**APPLICATION NO:** SSD-57107216 (Our Ref. 25-2023-9-1)

**PROPOSAL:** Tomago Battery Energy Storage System

**PROPERTY:** 1902 and 1940 Pacific Highway, Tomago (Lot 2 and 3 DP 1043561)

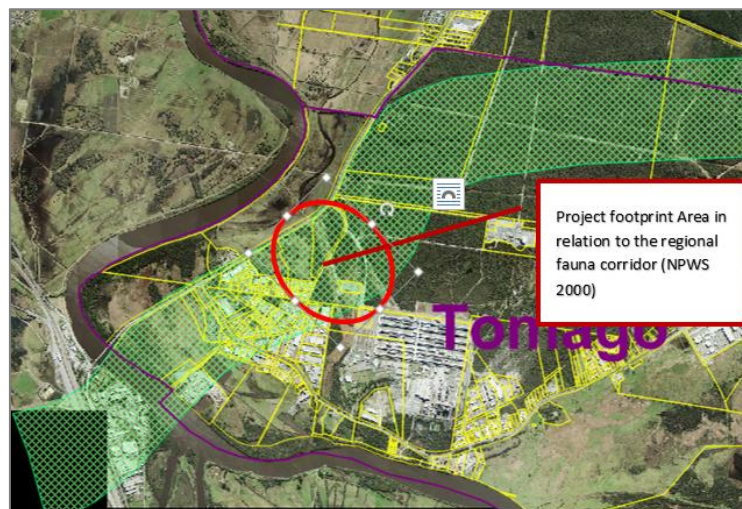
The proposal is located within an identified regionally significant fauna habitat corridor as per the figure below (NPWS, 2000). The mapping identifies a significant fauna habitat corridor through the site. The proposal has the potential to impact on the value of this corridor for arboreal mammals. It is recommended that fauna connectivity structures for threatened arboreal mammals (such as rope bridges and glider poles) be installed to help maintain and improve connectivity across the site, particularly across the existing gas pipeline corridors between the proposed storage facility and the Newcastle Gas Storage Facility in the area identified on the figure below.
